**Agricultural machinery — Equipment
for sowing — Minimization of the
environmental effects of fan exhaust
from pneumatic systems**

AMENDMENT 1

Reference number
ISO 17962:2015/Amd.1:2021(E)

Figure 3 — Scheme of wind tunnel and of positions (A and B) of the sowing equipment to be tested

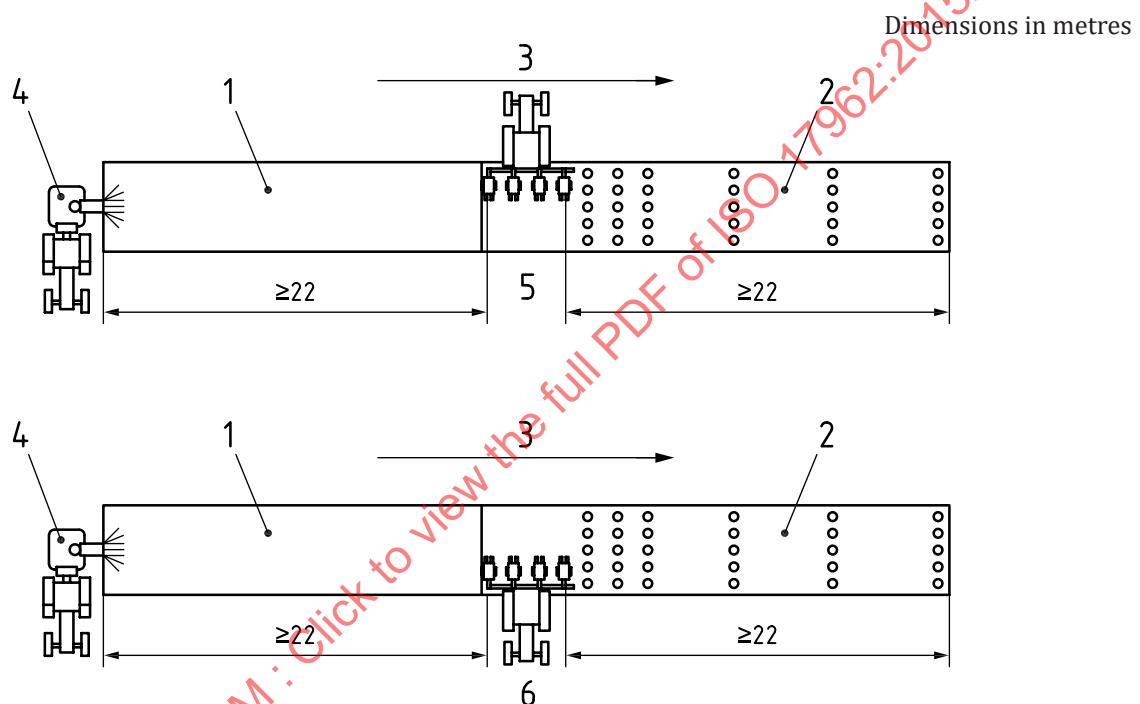
Add new subclause 3.4 as follows:

3.4 Wind tunnel test method

3.4.1.1 The testing area shall be a wind tunnel (see Figure 3). The floor surface of the wind tunnel shall be a soil prepared for sowing as specified in the operator's manual. The test conditions of the soil shall be recorded in the test report.

Following the flow of air, the tunnel will continue around the sowing equipment providing a hole as small as possible allowing to place the equipment into the tunnel.

3.4.1.4 The sowing equipment shall be tested in two positions A and B (see Figure 3). One position (A) is with the air stream moving transverse the direction of travel of the sowing equipment from left to right. The second position (B) is with the air stream moving transverse the direction of sowing equipment travel from right to left. The release point of the vacuum fan shall be at least 22 metres from the end of the wind tunnel.
